TOWN OF YORKTOWN PLANNING BOARD

PUBLIC MEETING AGENDA YORKTOWN TOWN HALL BOARD ROOM 363 Underhill Avenue, Yorktown Heights, NY 10598

August 16, 2021
7:00 PM

RE: Crystal Court Subdivision Mitigation Plan

PROPOSED MITIGATION PLANTING PLAN
1 IN. = 30 FT.

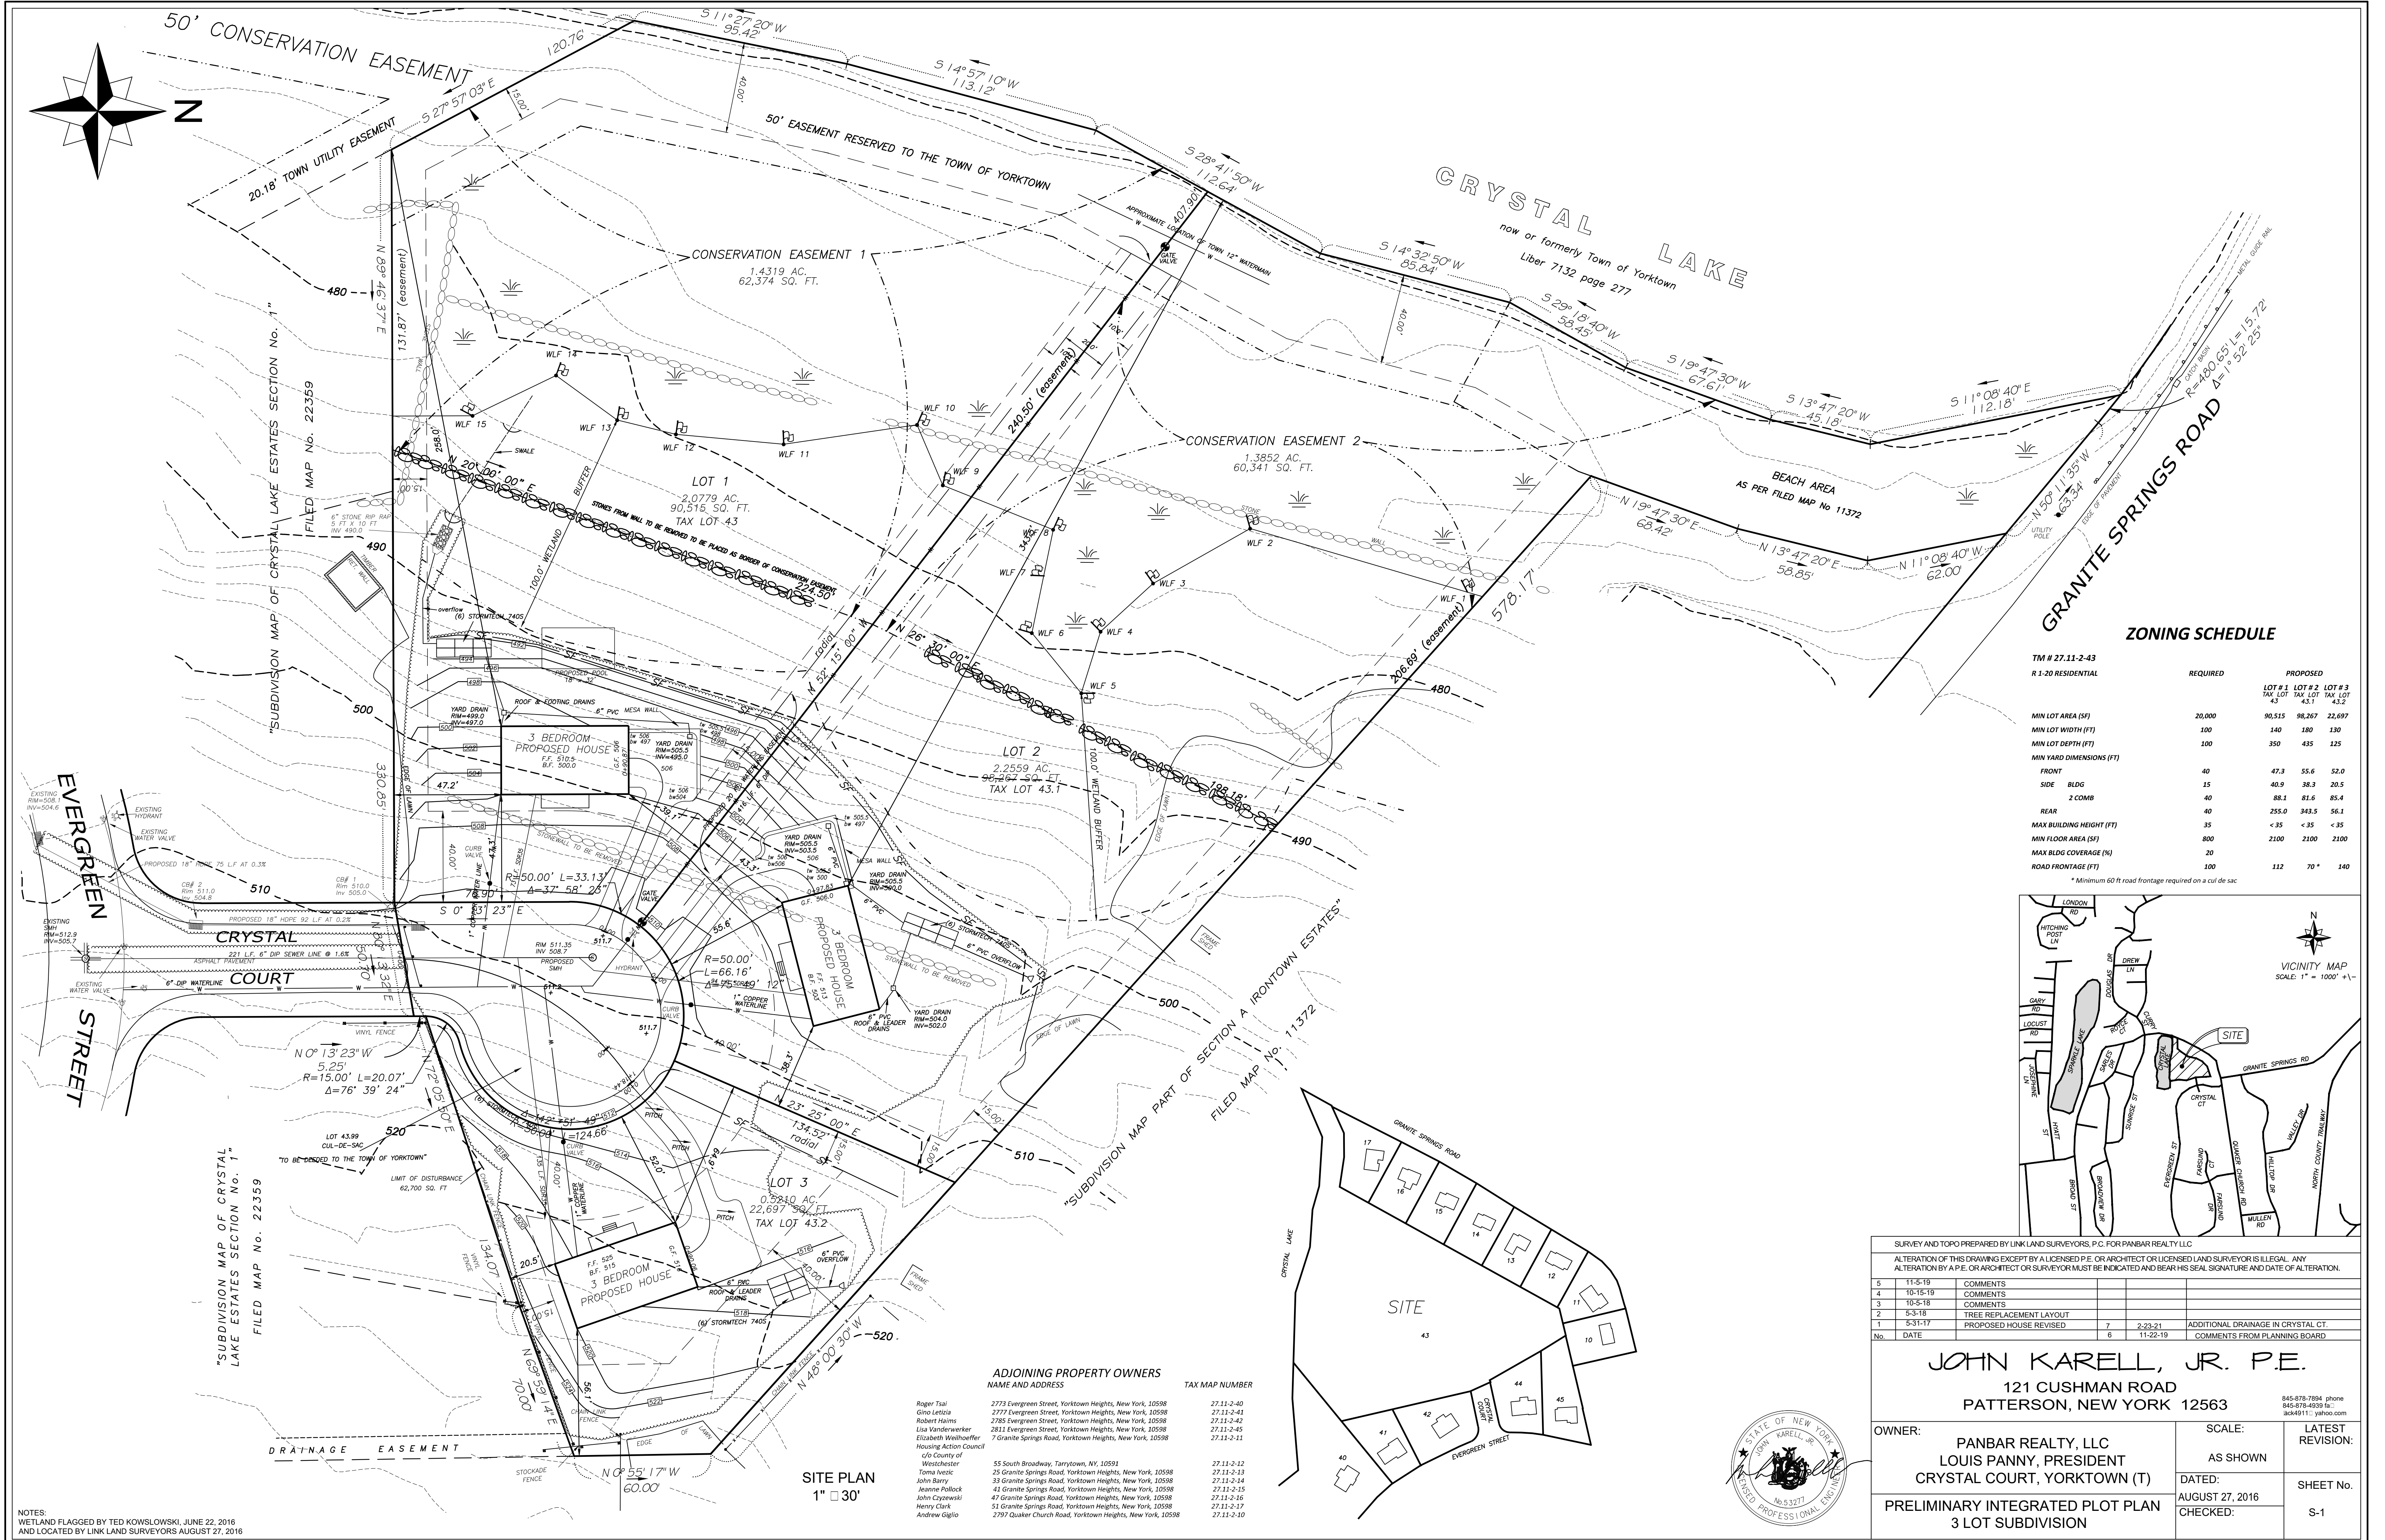
The TCAC received the mitigation Plans for Crystal Court subdivision and have the following comments.

2. Tree removals on lots 2 and 3 appear to be excessive; a number of trees slated for removal could be retained.
3. The tree sizes in the proposed mitigation planting plan are noted in inches at breast height. Nursery stock of trees are measured in caliper.

5. TCAC suggests the planting of native species. Chapter 270 - 10.C(4)
Winterberry - *Ilex Verticillata* and Spice Bush - *Lindera Benzoin*
6. Mitigation Planting Plan has notes listed regarding removal of Multi-Flora Rose. #6 monitor areas to determine follow up does not specify time period.

7. The Mitigation Plan is not sufficient in equaling the total disturbance of the existing ecosystem. A \$500 contribution to the Yorktown Tree Fund should be levied.
